COMPLIANCE REPORT

7 Ripon Street, YOUNG NSW

Hennessy Catholic College

Hilltops Certifying Services
91 Boorowa Street, Young NSW 2594

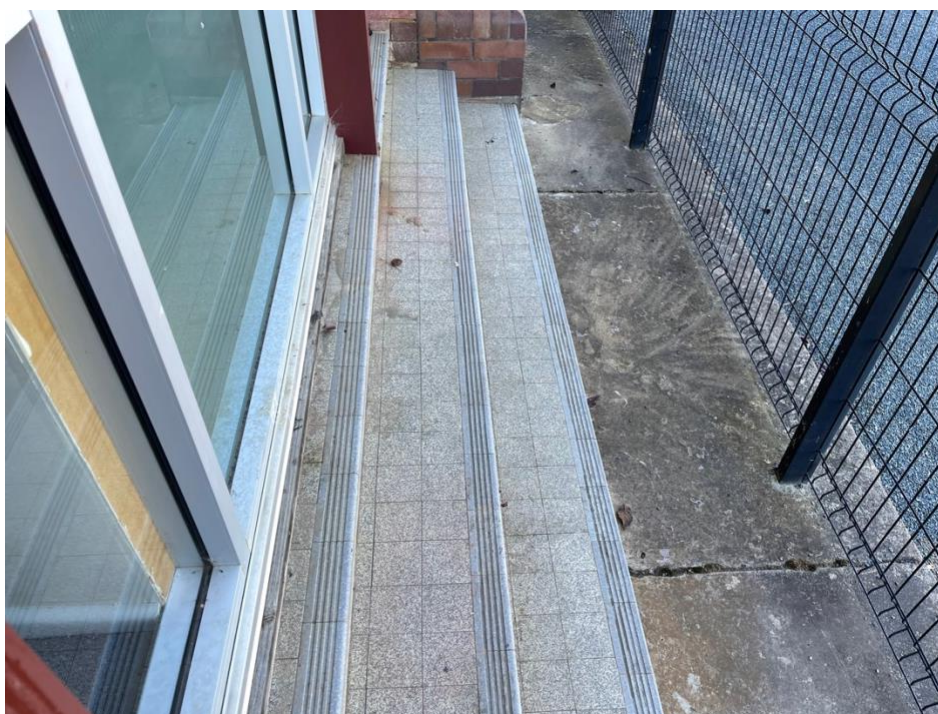
D2.13	Goings and Risers	Overall review of the stairs needs to be undertaken	$2R+G$ Main internal: = 610 Rear door: = 600 Co-ordinators room: = 780* Out of range & uneven. The steps are uneven with the bottom step being

<p>different and the gate being out of range making this a trip hazard</p> <p>Math science room: = 610 Open stair: = 610*</p> <p>Type of stair is a question. These are built as a fire step but are clearly general access. They fail , in many areas</p> <p>Fire stairs: = 550* The gap between goings exceeds 125mm</p> <p>Dept Principal: = 570</p>
D2.14	Landings	For the existing stairs, there is a variety of compliant and non-compliant. Needs addressing	The stairs over the site meet with general compliance for landings under this Part, but most will fail under the APS in the access assessment. Landings at doorways are failures in many areas due to thresholds and circulation spaces
D2.15	Thresholds	General compliance over the building is inconsistent. Issues with PPE thresholds need to be addressed	There are issues for thresholds over the building. all external and some internal doors fail in this area. There are barriers with there being steps in the path of travel for the stair room, transition from entry to the main hall, end of the hall. Up stars there is issues at the change of building to the PE staff room. Full review in design required
